City of Mississauga Department Comments

Date Finalized: 2024-06-05	File(s): A221.24
To: Committee of Adjustment	Ward: 9
From: Committee of Adjustment Coordinator	Meeting date:2024-06-13 1:00:00 PM

Property Address: 6074 Leaside Cres

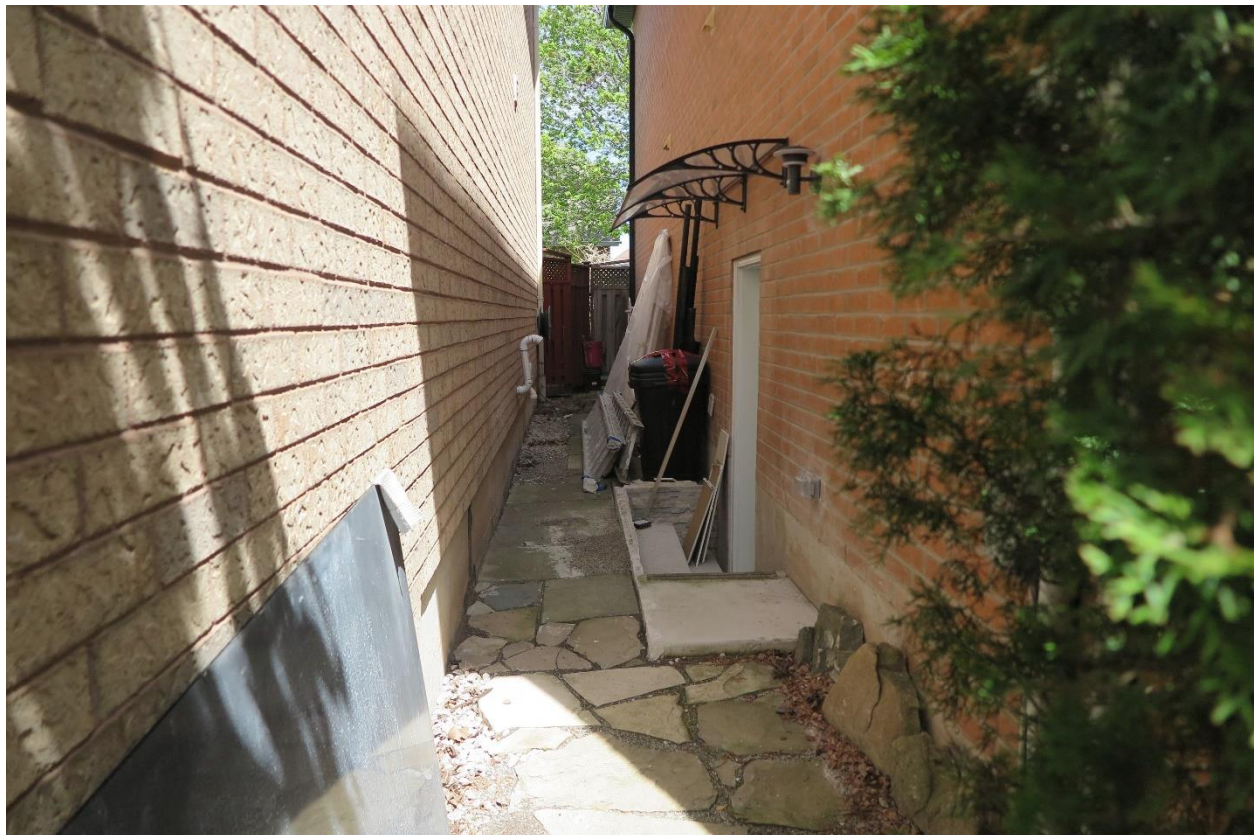
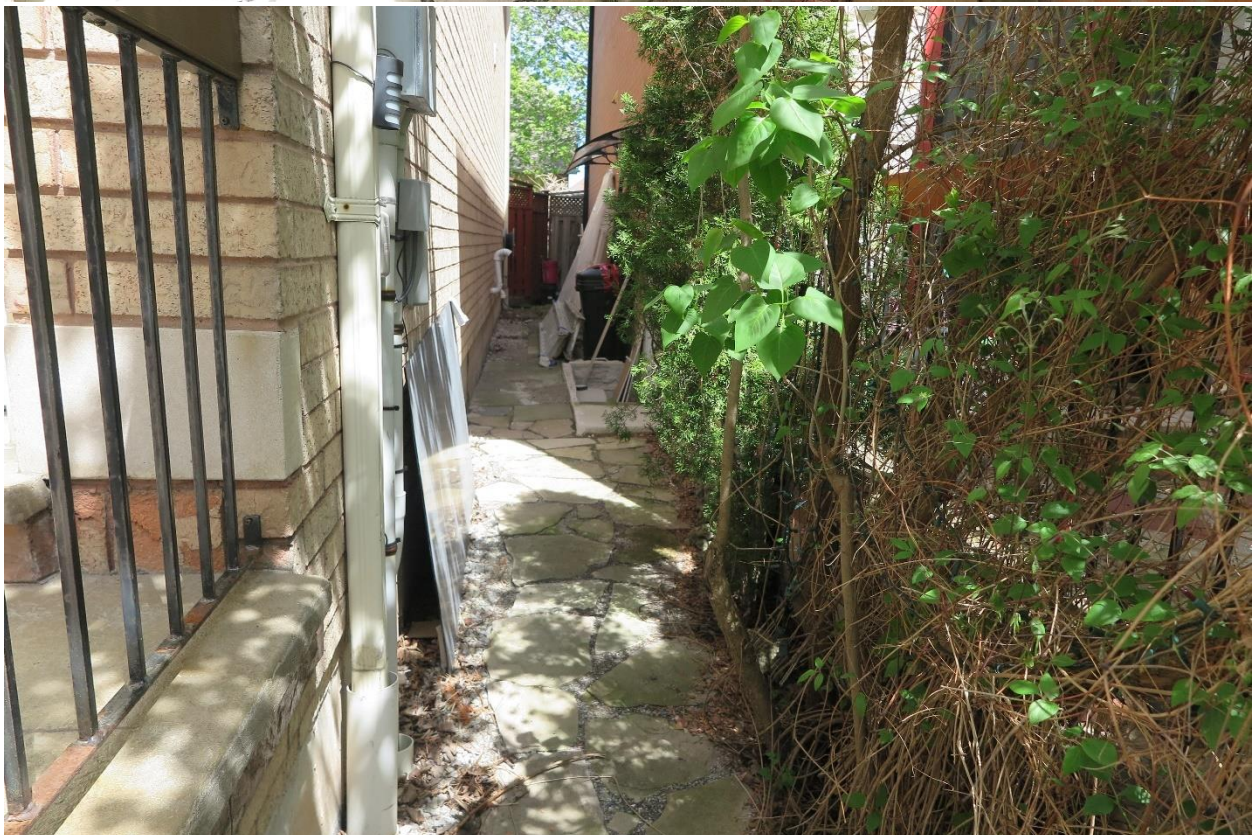
We note that this property has a split drainage pattern which means that the high point is approximately in the middle of the dwelling in the area of the entrance stairwell. With the minimal 0.04M setback requested a drainage swale would not be functional, however, in this instance we do not foresee any significant concerns as the entrance is located at the high point and drainage could still be directed to both the front and rear of the dwelling.

It is clearly evident from the enclosed photos that what currently exists on site is not functional, in fact the owner has placed steps within the stairwell which exit onto the neighbouring property. The Site Plan submitted depicts a 23-inch timber retaining wall with a wider walkway (abutting the dwelling) which would allow for access to be restricted to the subject property and not having to utilize the neighboring property which would be an improvement over what currently exists.
